**Re: FortisBC Energy Inc. (FEI)**

**Application for a Certificate of Public Convenience and Necessity (CPCN) for the Tilbury Liquefied Natural Gas Storage Expansion (TLSE) Project (Application)**

**Response to the Residential Consumer Intervener Association (RCIA) Information Request (IR) No. 5**

**Figure 3-8: Timeline for AV-3 Service Restoration (with AMI)**

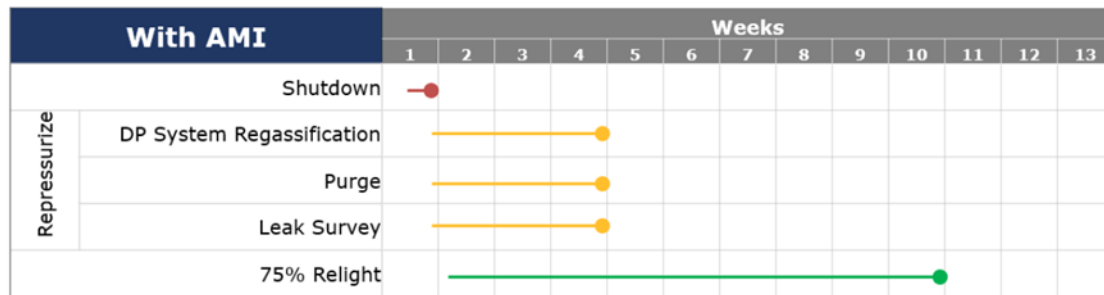
65.1 Please confirm whether the leak survey timeline shown in Figure 3-8 is based on FEI using mobile leak detection technology. Mobile leak detection allows vehicle-mounted leak detection instruments to perform leak surveys while the vehicle travels at posted speed limits. If not confirmed, please estimate the reduction in leak survey time from implementing such technology.

FEI assumed that field crews would use FEI's existing capabilities for leak surveying the Distribution Pressure (DP) system, which consists of handheld portable leak detection devices (e.g., flame ionization) and walking the system. FEI did not attribute a material amount of time to conducting leak surveys during the re-pressurization process; thus, the implementation of mobile leak survey technology would not have a material impact on shortening FEI's timeline to re-pressurize a collapsed Lower Mainland system. This is demonstrated in the Figure 3-8 timeline by observing that the regasification, purge, and leak survey activities all occur in parallel with one another.

FEI is, in fact, anticipating that most areas of the system—where the segment is holding its pressure as gas is reintroduced (which FEI refers to as a pressure check)—a leak survey would occur at the same time FEI is relighting appliances in that area. Leak surveys and purging conducted in the manner FEI is anticipating reduces risk of harm and contribute relatively little to the overall timeline for full resumption of service to the Lower Mainland.

**Figure 1: Cumulative Rate Impact of FEI's Current and Proposed CPCN and OIC Projects**

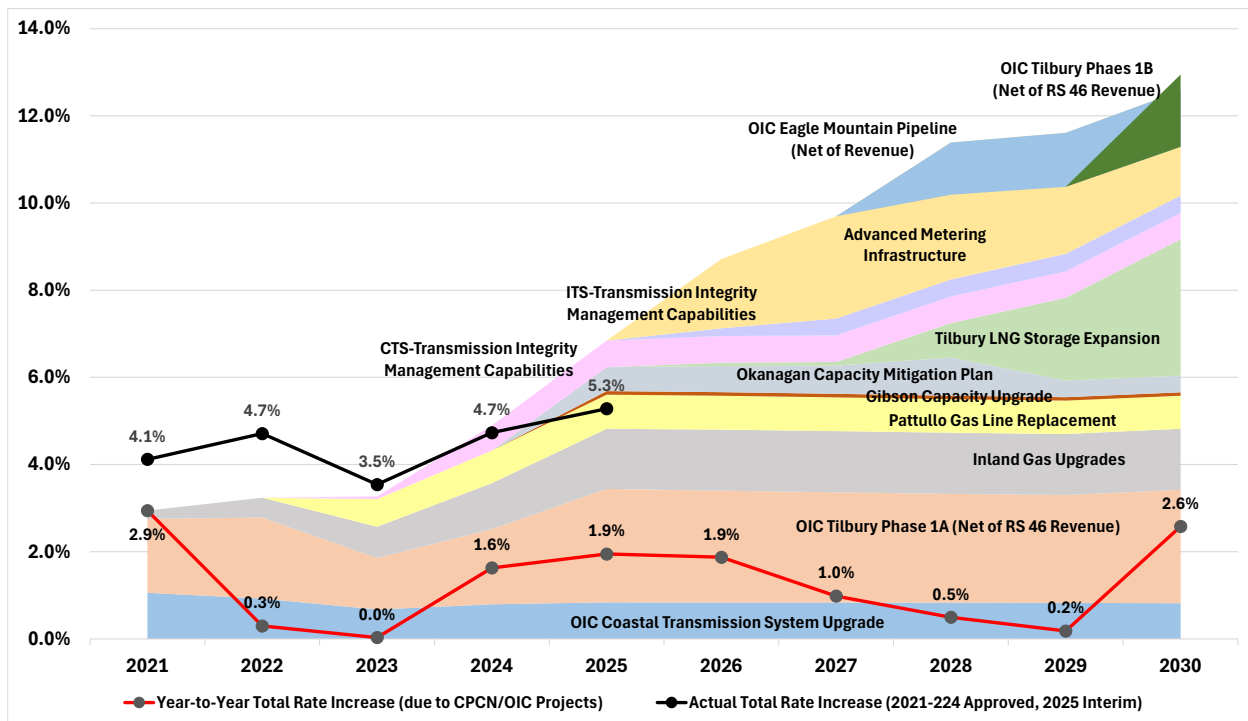
69.2 Please provide an update of the graph on page 5 of Exhibit B-4 in the CTS TIMC proceeding showing the forecasted rate impacts for each of FEI's current and proposed CPCN and OIC projects. Please also show the actual delivery rate increases to date.

Please refer to Figure 1 below for an updated cumulative and year-over-year total rate increase for FEI's current and proposed CPCN and OIC projects from 2021 to 2030. FEI also included the actual total rate increase to date from 2021 to 2024 Approved and 2025 Interim. FEI notes that the figure on page 5 of Exhibit B-4 of the CTS TIMC proceeding, dated May 13, 2021, provided the total rate increase due to CPCN and OIC projects, not the delivery rate increase. For consistency, the numbers in percentage shown in Figure 1 below are also based on the total rate increase.

As shown in Figure 1 above, the cumulative total rate impact from 2021 to 2030 due to FEI's current and proposed CPCN and OIC projects is approximately 12.9 percent, which is equivalent to an average of 1.3 percent over the 10-year period. FEI notes that the primary differences

1 between the updated cumulative total rate increase shown in Figure 1 above and the increases  
2 provided in the 2021 CTS TIMC proceeding are due to:

- 3 • The delay of the proposed TLSE Project with all assets now estimated to be included in  
4 FEI's rate base in 2031;
- 5 • The delayed start of the approved AMI project to 2025;
- 6 • The removal of the rate impact due to the Okanagan Capacity Upgrade (OCU) project and  
7 the inclusion instead of the approved Okanagan Capacity Mitigation Project (OCMP);
- 8 • Inclusion of new projects:
  - 9 ○ Approved ITS TIMC CPCN Project
  - 10 ○ Approved Gibson Capacity Upgrade (GCU) Project
  - 11 ○ OIC Approved Eagle Mountain Pipeline (EGP) Project
  - 12 ○ OIC Approved Tilbury Phase 1B Project
- 13 • For the OIC Approved Tilbury Phase 1A, Tilbury Phase 1B, and the EGP projects, a  
14 forecast of offsetting revenues is included.

15 Finally, FEI notes that the total rate impacts due to the current CPCN and OIC projects shown in  
16 Figure 1 above are for illustration only and do not represent FEI's estimated rate changes for 2025  
17 to 2030. The actual rate changes for FEI will not be dependent on these projects alone as there  
18 are various factors such as the demand forecast, taxes, O&M expenses, and other capital  
19 additions (i.e., regular capital) that will also affect FEI's revenue requirement and rate changes.
